**MICROCHIP****PIC18F6390/6490/8390/8490****PIC18F6390/6490/8390/8490 Rev. B3 Silicon Errata**

The PIC18F6390/6490/8390/8490 Rev. B3 parts you have received conform functionally to the Device Data Sheet (DS39629B), except for the anomalies described below. Any Data Sheet Clarification issues related to the PIC18F6390/6490/8390/8490 will be reported in a separate Data Sheet errata. Please check the Microchip web site for any existing issues.

The following silicon errata apply only to PIC18F6390/6490/8390/8490 devices with these Device/Revision IDs:

FIGURE 1: SCK PULSE VARIATION USING TIMER2/2

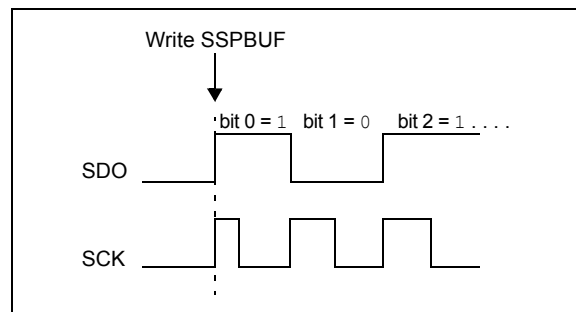
When the SPI is using Timer2/2 as the clock source, a shorter than expected SCK pulse may occur on the first bit of the transmitted/received data (Figure 1).

To avoid producing the short pulse, turn off Timer2 and clear the TMR2 register, load the SSPBUF with the data to transmit and then turn Timer2 back on. Refer to Example 4 for sample code.
